# UNITED STATES PATENT AND TRADEMARK OFFICE

*Supplemental*  
**Office Action Summary**

10/693,398

### **DETAILED ACTION**

**Figure 1.** Diagram showing separation of section with the combination of Horzweski and Leschinsky. The 2nd type of section is adjacent to the 1st and 3rd types of section. The 1st and 3rd sections have the same elasticity and the 2nd and 4th sections have the same elasticity.

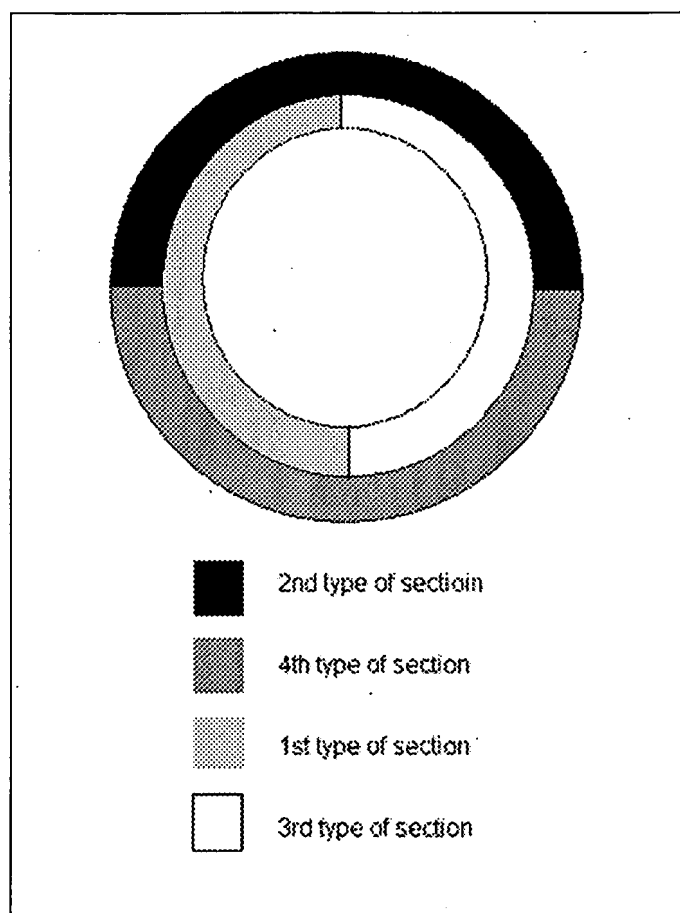
conduit that has third and fourth types of section in a circumferential direction. Although the layers are oriented with one layer outside the other layer, they are still comprised of first through fourth types of sections in a circumferential direction (see Fig. 1 below).

blood clot filter, or occluder, the device being foldable for delivery through the conduit and in a second manner different from the first manner for retrieval. Stents, blood clot filter, and occluder are well-known devices to be inserted through a conduit and into a lumen of a body such as a blood vessel. It is also well-known that these devices are folded into a smaller collapsed diameter so that they can be easily inserted into a delivery device. The expanded, deployed diameter of a stent, blood clot filter, and occluder is well-known to be larger than its initial diameter. Therefore, it would have been obvious to one having ordinary skill at the time of the invention to have modified Horzewski et al. with the medical device being a stent, blood clot filter, or occluder in order to be inserted into a body lumen. Howzeski et al. also disclose a conduit that has third and fourth types of section in a circumferential direction. Although the layers are oriented with one layer outside the other layer, they are still comprised of first through fourth types of sections in a circumferential direction (see Fig. 1 above).
